## APPENDIX E.13

### Responses to 2023 Annual Report Comments

Table A.1: Response to QIA Comments on Baffinland’s 2023 QIA-NWB Annual Report for Operations

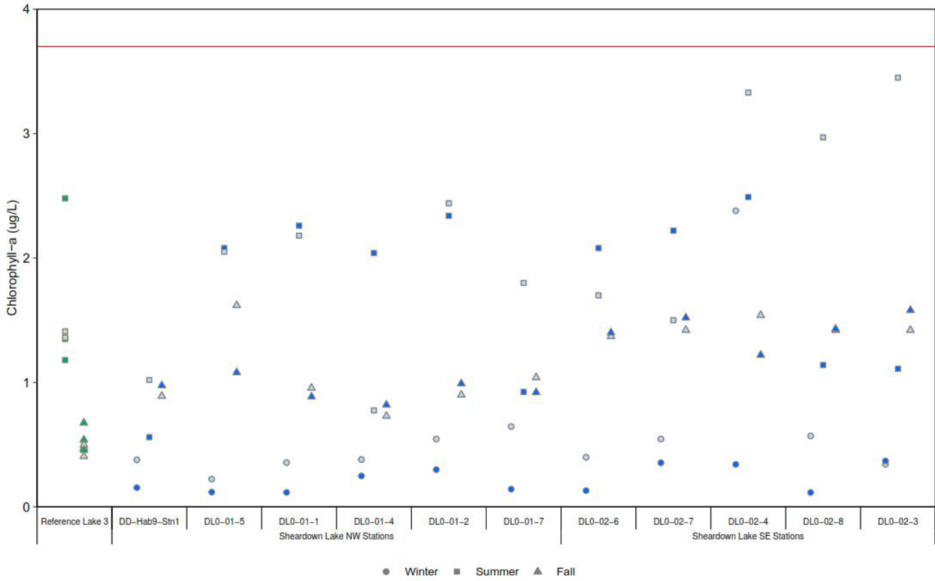
| f  | Intervener<br>Cmt. No. | Intervener Comment   | Intervener Recommendation/Response  | Baffinland's Response  |
|----|------------------------|--|---|--|
| 11 | CREMP#4                | <p>At several stations it was observed that there were occurrences of elevated chlorophyll-a at Camp Lake, Sheardown Lake Tributary 12, and the Sheardown Lake NE and SW stations. While these concentrations were below the AEMP benchmark of 3.7 µg/L, they were elevated compared to 2023 seasonal samples from the same site reference and/or background. It does not appear that any further investigations were completed to identify the source or reason for the elevated chlorophyll-a concentrations.</p>  | <p>Baffinland should include discussion in the report on chlorophyll-a samples that are approaching the AEMP benchmark. This discussion should include potential reasons for the elevated results and any follow up investigations that are being considered. Sites where chlorophyll-a are trending upward should also be flagged for future monitoring.</p> | <p>Baffinland provided discussion on chlorophyll-a concentrations that were higher at Camp Lake Tributary 1 (CLT1) than the reference creek in 2023 for the Section referred to by QIA (i.e., Section 3.1.3; page 79). Baffinland conducted benthic invertebrate community monitoring at the upper main stem of CLT1 in the past, as well as in 2023, which showed no adverse effect on the benthic invertebrate community.</p> <p>As discussed in the CREMP, for each of Camp Lake, Sheardown Lake Tributary 12, Sheardown Lake NE, and Sheardown Lake SW, average chlorophyll-a concentrations in 2023 were within the seasonal ranges previously observed (i.e., 2014 to 2022) and showed no consistent directional changes for any of the winter, summer, or fall seasons over time. These analyses have not indicated an upward trend, nor suggested a mine-related cause for the occasionally higher concentration of chlorophyll-a at any individual station within a given year. Because no mine-related change in chlorophyll-a concentrations has occurred, the existing AEMP Rev. 1 framework does not require additional investigation or follow-up analyses.</p> <p>Despite concentrations of chlorophyll-a occasionally approaching the AEMP benchmark at individual stations within mine-exposed waterbodies, similar ‘elevated’ concentrations were observed at individual stations of the reference lake (refer to CREMP Figures 3.11, 4.9, and 4.17 in which chlorophyll-a concentrations in fall 2015</p> |

| f  | Intervener Cmt. No. | Intervener Comment   | Intervener Recommendation/Response   | Baffinland's Response  |
|----|---------------------|--|--|--|
|    |                     |  |  | and summer 2023 appeared 'elevated') and the reference creek (refer to CREMP Figure 4.3 in which chlorophyll-a concentrations in spring 2014 and fall 2014 and 2019 appear 'elevated'). Therefore, the chlorophyll-a concentration results observed at the various mine-exposed waterbodies appear to be in line with results documented at the reference areas. Baffinland will continue to monitor chlorophyll-a concentrations at all stations indicated within the CREMP in accordance with those committed to under the AEMP; no requirement for sites to be "flagged for future monitoring" is necessary.  |
